NS-TMA-2219

Westinghouse
Electric Corporation

March 14, 1980

Question 12

2 INCH COOLD LEG BREAK
UPPER HEAD TEMPERATURE
(* T SATURATED)

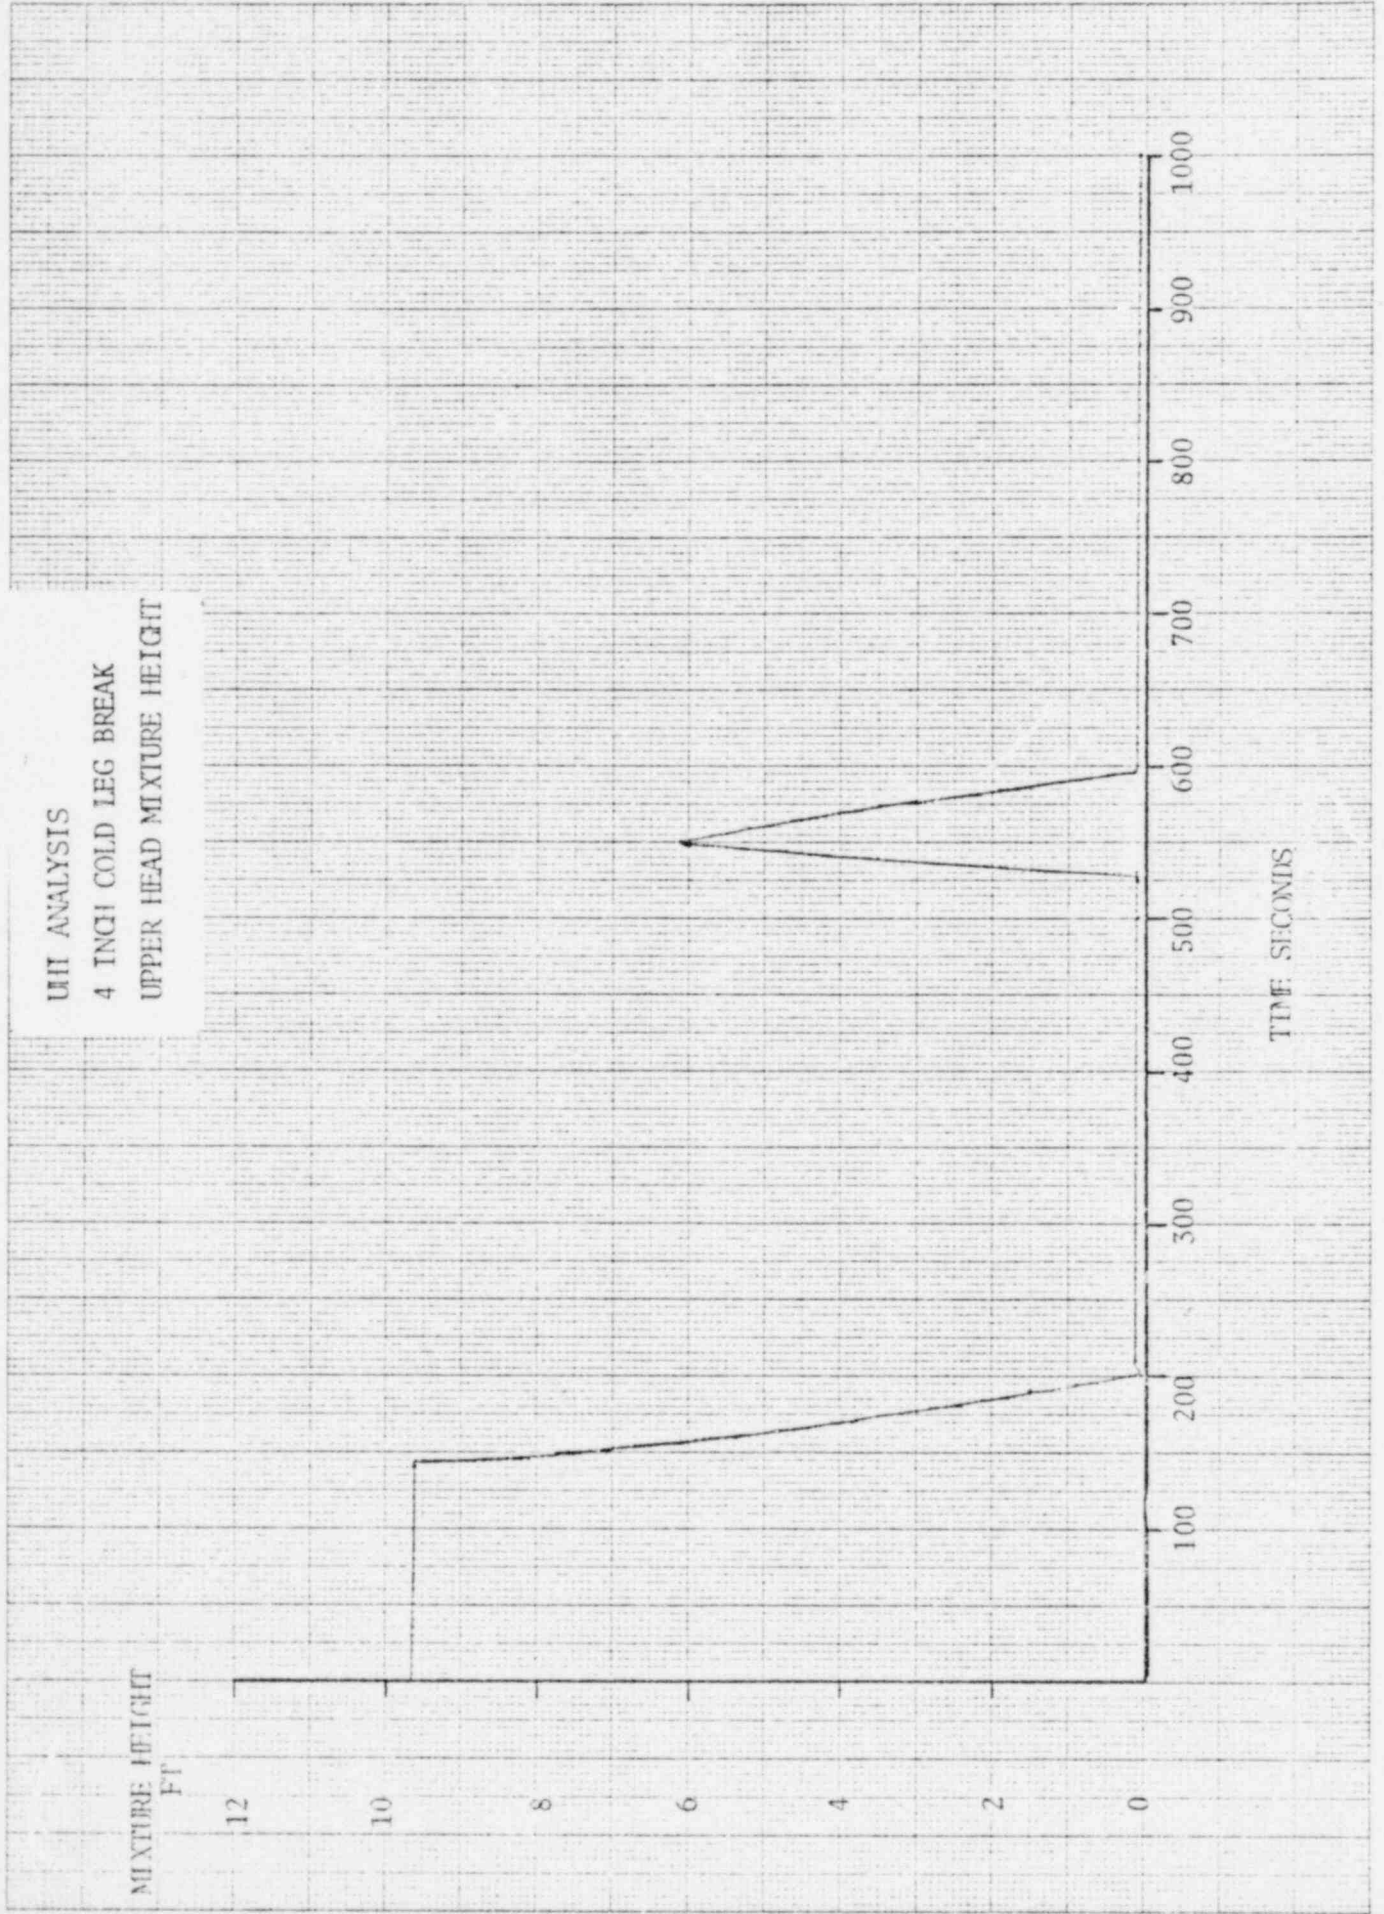
The plots of requested system parameters for the breaks analyzed in WCAP 9639 are attached.
